MEMORANDUM

SUBJECT: Item 4.1, DA2023/0368 – 1&CP 9-15 Central Avenue, Manly, Fit out and use of the courtyard for the seating of 100 patrons, operating from 8.00am to 10.00pm (same as existing).

REFERENCE: Applicants response to the NBLPP deferral of application 13 December 2024

Figure 5.2 Extent of awning extension above courtyard (Option 2)

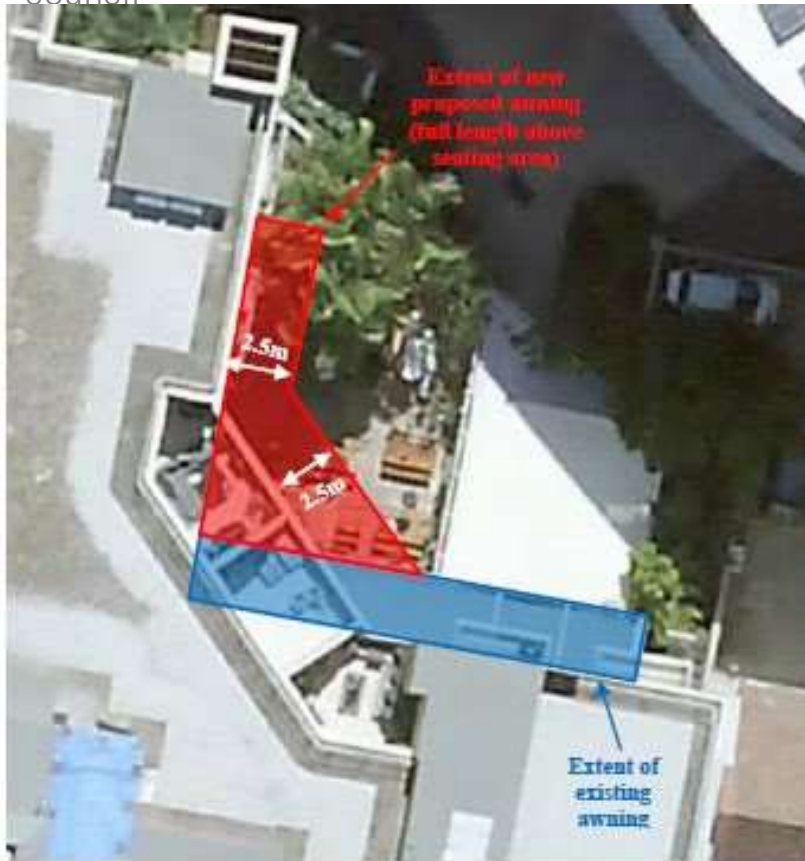
Two noise attenuation methods have been suggested for the courtyard (operable roof and awning extension). The use of the operable roof relies on staff to count the number of patrons in the outdoor courtyard in order to determine how much of the roof is to be utilised to reduce noise.

The existing awning however is fixed and its extension inoperable once in place. This is Council's preferred option.

The Environmental Health Officer comments state a preference for Option 2, where a permanently solid roof awning is to be provided. This recommendation is a desirable outcome and forms part of the recommended conditions of approval.

Hence, a condition to enforce the preferred Option 2 of the acoustic report is recommended.

- a) Construction of awning roof / extension as conceptually detailed in Part 5.2 Option 2 – Awning extension in the Acoustic Impact Assessment No. PS131027-101 WSP 24 March 2023, referenced on Condition No.1 of this consent.
- b) the maximum height of the awning extension is to be no higher 4.2m above the existing ground level of the courtyard on Lot CP SP 61679.
